Subject: Duke Energy Corporation
Oconee Nuclear Station - Units 1, 2, and 3
Docket Nos. 50-269, 50-270, and 50-287

Revisions to Topical Report DPC-NE-3003 In Support of
Steam Generator Replacement
Response to NRC Staff Request for Additional
Information

Duke Power Response To Request For Additional Information

DPC-NE-3003 Revision 1 “Mass and Energy Release and Containment Response Methodology”

GOTHIC 7.0 - FATHOMS COMPARISON
ROTSG LARGE BREAK LOCA
(8.55 ft² Break - Cold Leg Pump Discharge)

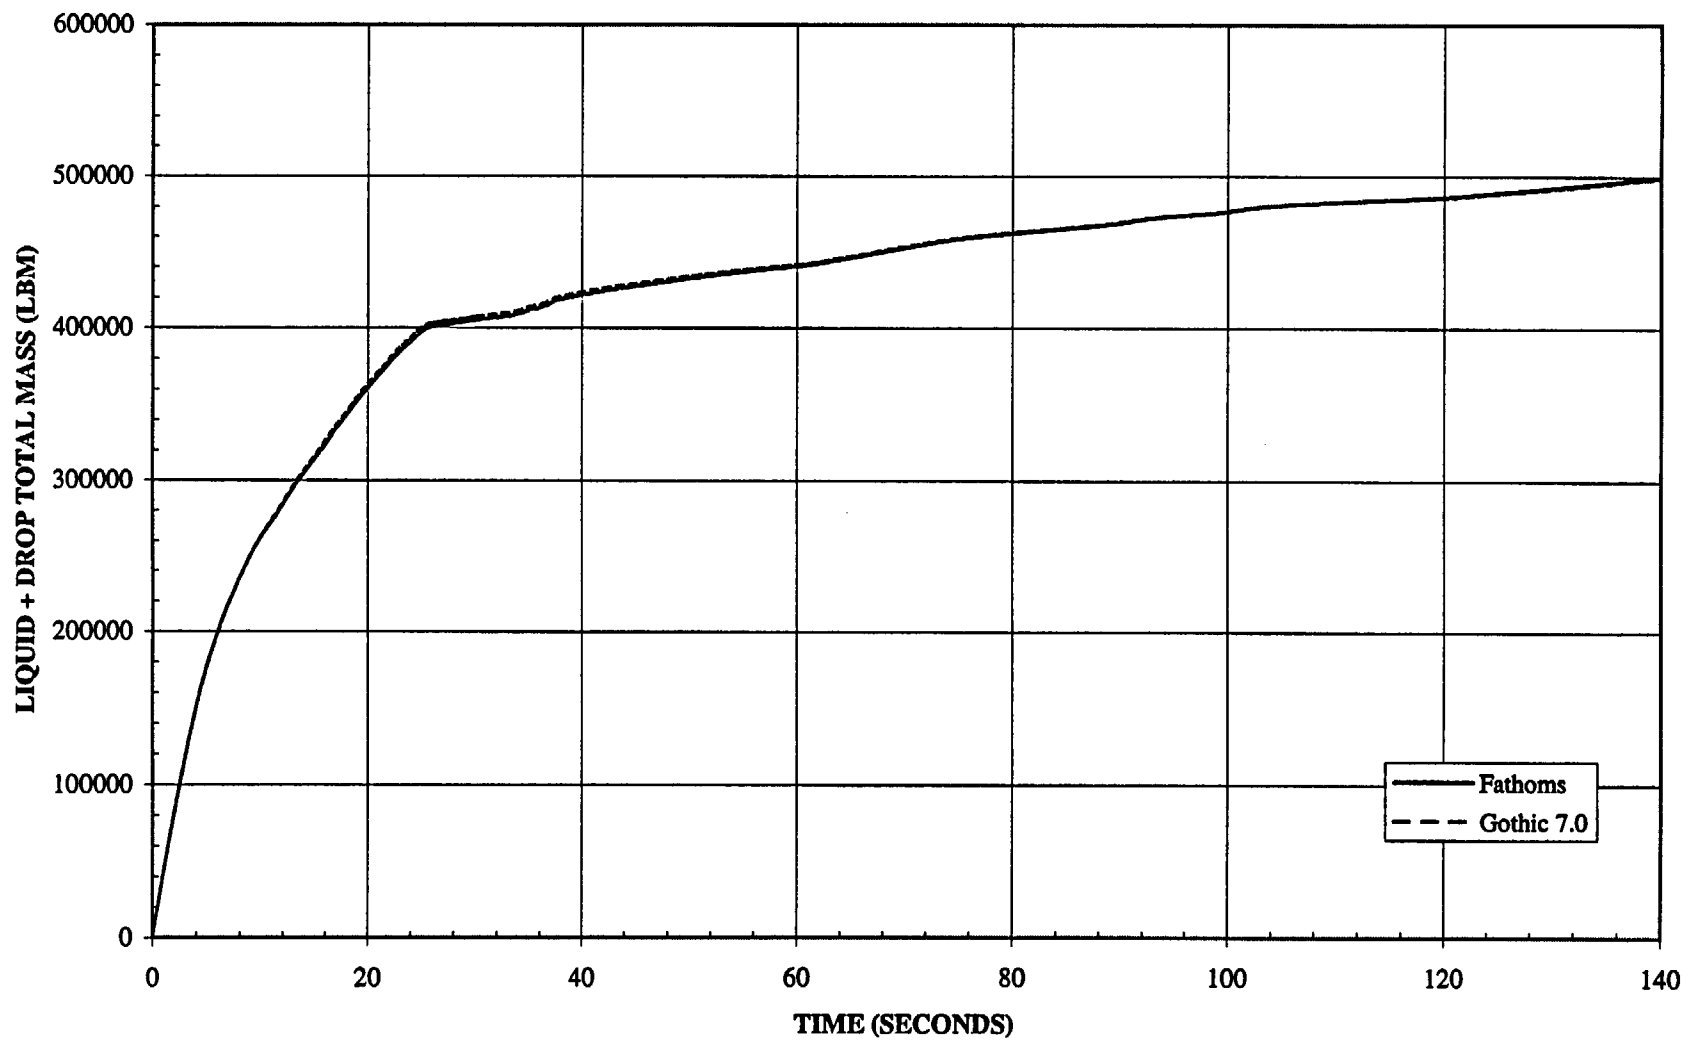
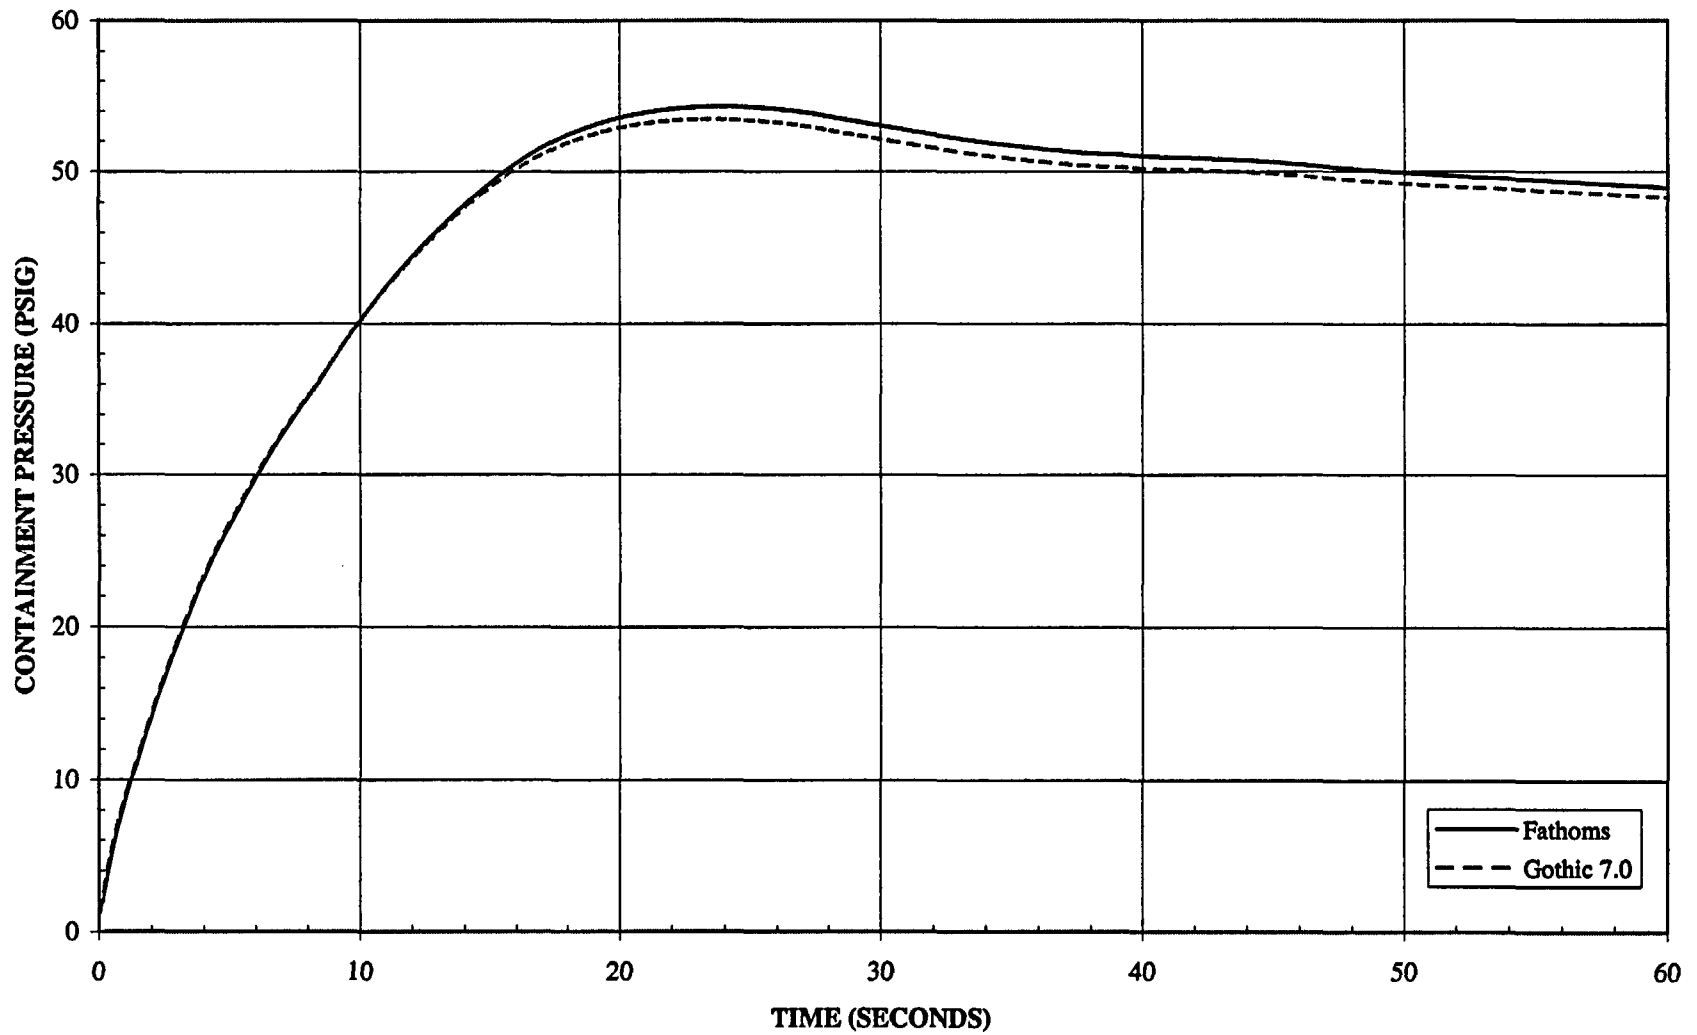
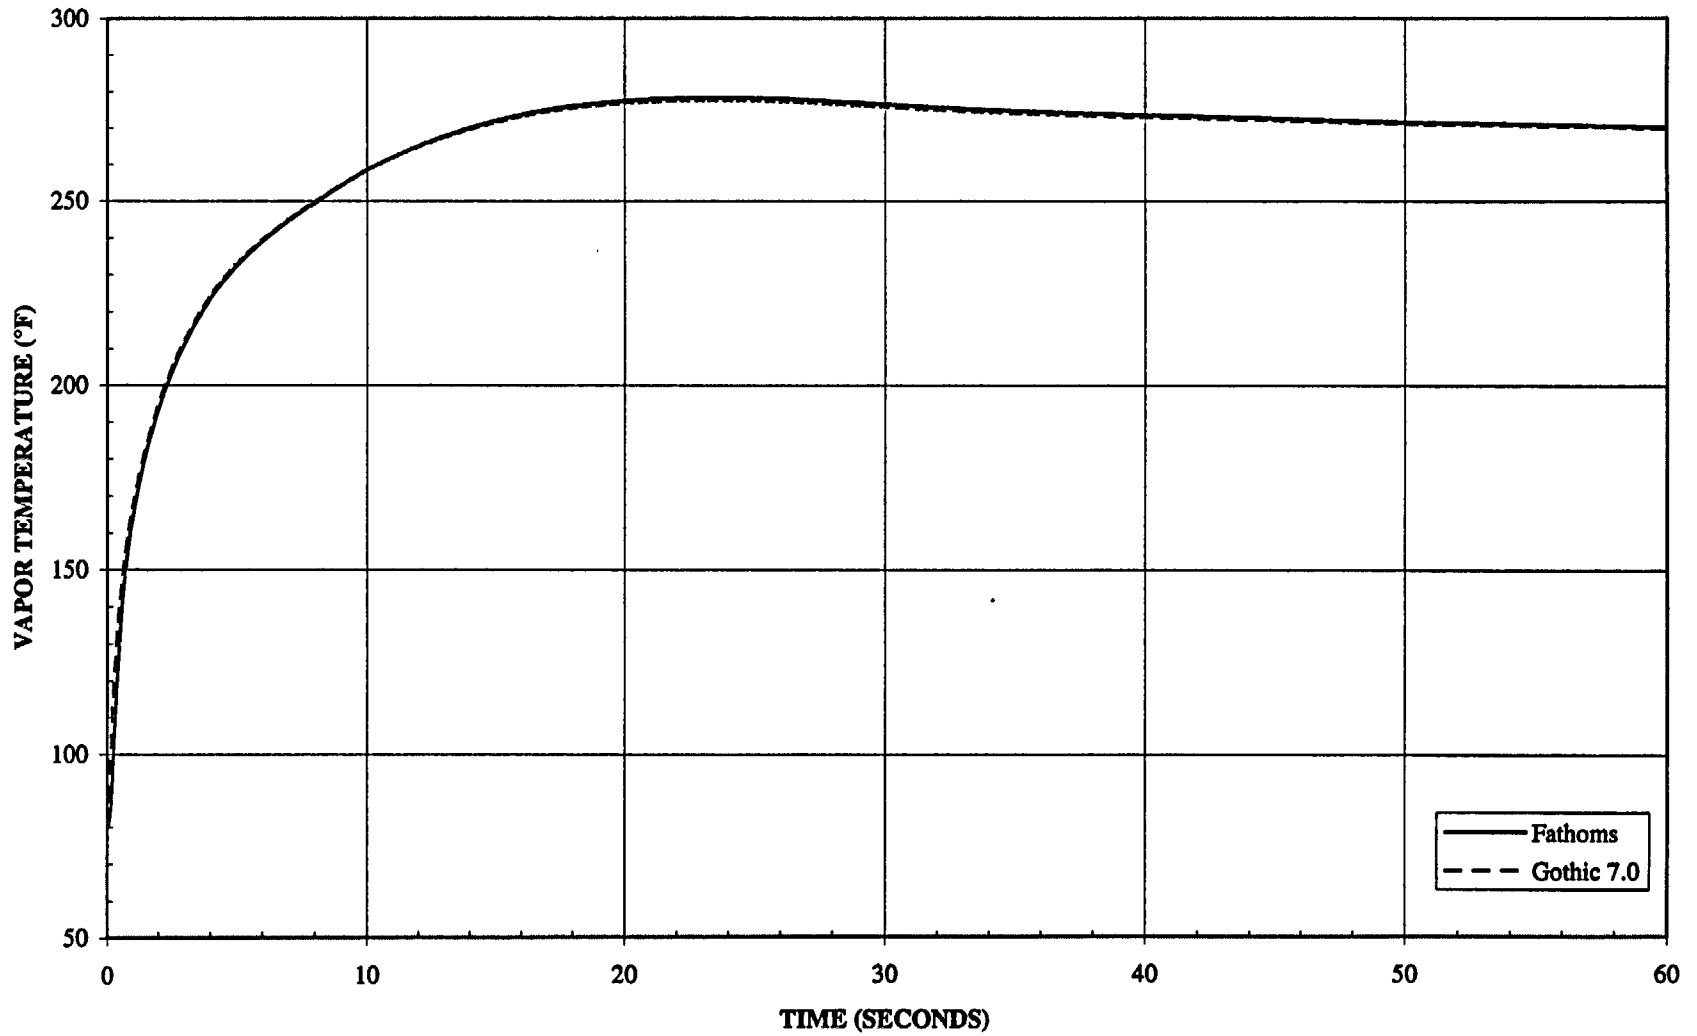
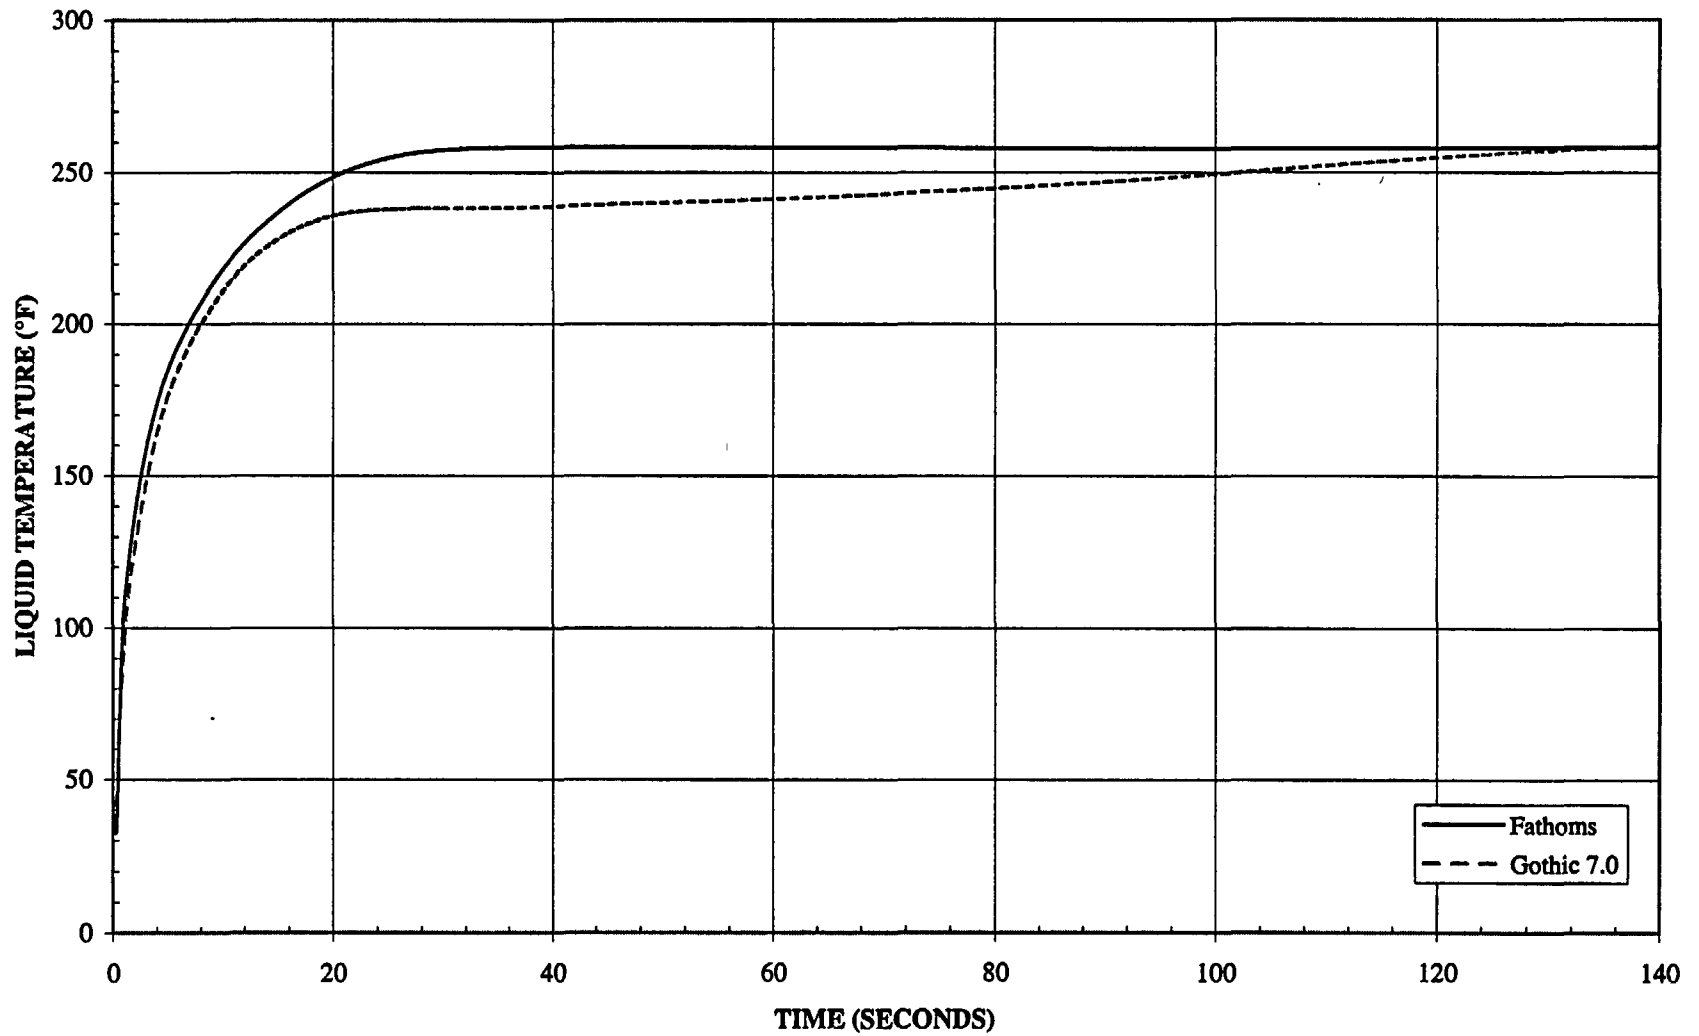
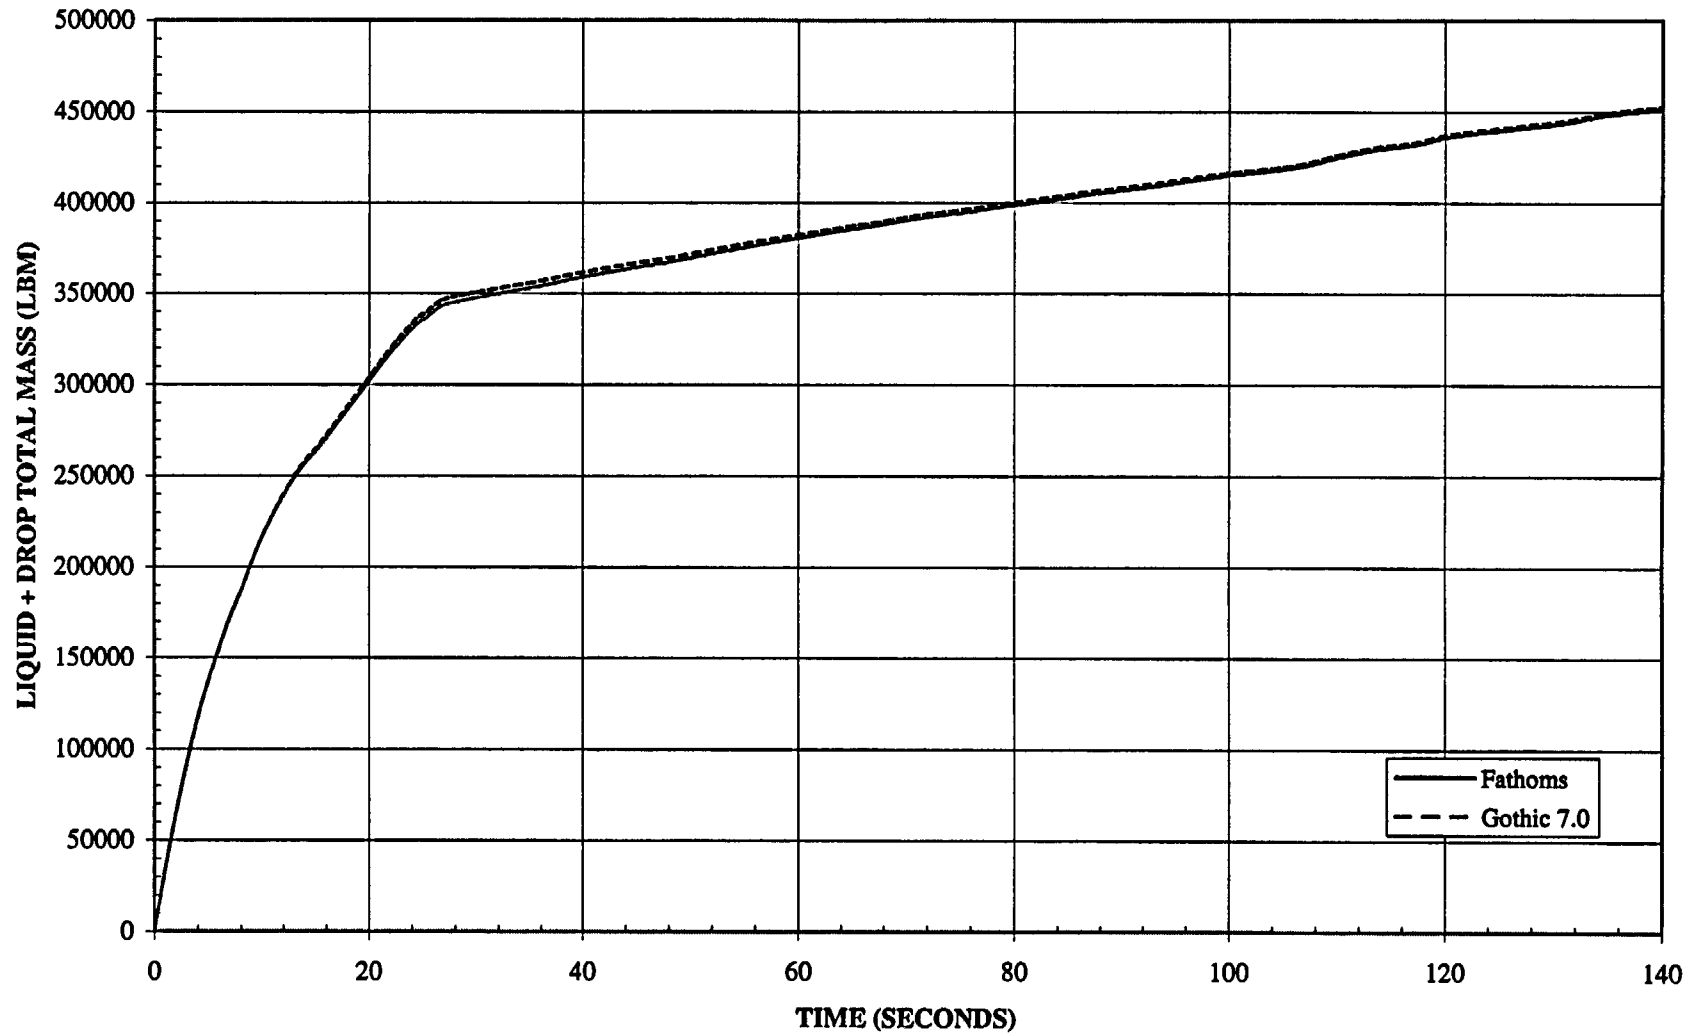
3. Please provide the results using the GOTHIC 7.0 code of peak pressure and temperature calculations for the sensitivity cases listed in Table 3.1-1 of DPC-NE-3003 in tabular and graphical form. If the results or conclusions are significantly different from those presented in DPC-NE-3003P, explain the difference.

Response: Table 3.1-1 of DPC-NE-3003 describes a spectrum of LOCA peak pressure cases including a range of break locations and sensitivity analyses for several important modeling assumptions. The staff's request is understood to focus on the difference in the predicted results from the FATHOMS and GOTHIC 7.0 code versions. Rather than show the comparison for the cases in Table 3.1-1, a different set of cases has been selected which is more focused on the current knowledge of the key sensitivity parameters. Also, the results presented are for the ROTSGs, which is the subject of Revision 1 to the topical report.

The results of the 14 code comparison analyses are shown in Table 3-1 below and in the figures that follow. In general, the pressure and vapor temperature response predictions were very similar in both magnitude and trend. GOTHIC 7.0 predictions for peak pressures and vapor temperature were slightly lower (~0.5 psig and 0.5°F). These differences are consistent with the code model differences described in the response to Question #1. Both codes predict a saturated containment atmosphere due to the large amount of drops injected. The slightly lower pressure, vapor temperature, and liquid temperature from GOTHIC 7.0 may be attributed to additional drop hold up in the atmosphere. This effectively increases the heat capacity of the atmosphere and reduces the temperature rise for a given energy addition. A comparison of the total liquid and drop masses, and liquid temperatures, show the predictions of the two codes to be essentially the same. This is consistent with the changes in the drop deposition and entrainment models discussed in Question #1. These results show that the two code versions give essentially similar results for the same break location and initial and boundary conditions.
